Overview Consultation Document Response

National Grid Electricity Transmission

August 2025

Figure 1: Demonstrates that Ofgem’s chosen range (purple shading) gives no consideration to the more recent economic context.

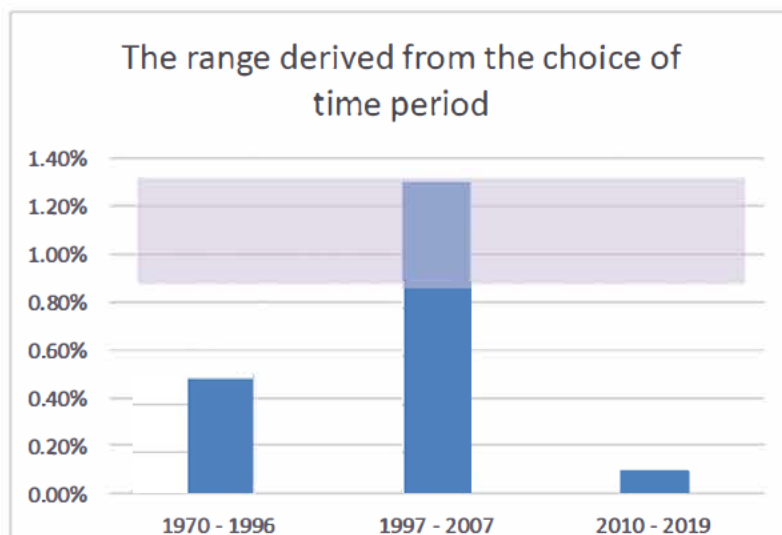
In relation to the second point, GTh has calculated estimates over three separate time periods: 1970-1996, 1997-2007 & 2010-2019. Figure 1 shows the results arising in each of the three windows – the purple shaded area shows Ofgem’s proposed DD range of 0.7% - 1.3%.

To determine the top of its proposed RIIO-T3 range, GTh has chosen to use the 1997-2007 time period. But the evidence (as shown in the chart) is stark that productivity growth in the period since the GFC has been materially lower. GTh does not provide any evidence that a reversion to the higher productivity achieved in the earlier period is feasible in RIIO-T3 despite the sustained lower productivity since the GFC. Instead GTh speculates that artificial intelligence might drive improvements which could have “potential parallels” with ICT improvements in the 1997 – 2007 period; and this could give Ofgem a reason to place more weight on that period (page 5). This is insufficient basis for GTh to then make the highly material methodological choice to place full weight on that period to define the top of its RIIO-T3 range. It also appears to contrast with GTh’s advice that Ofgem (rather than GTh itself) should

Ofgem must therefore apply an ongoing efficiency allowance no greater than the 0.7% proposed and evidenced in our business plan submission.
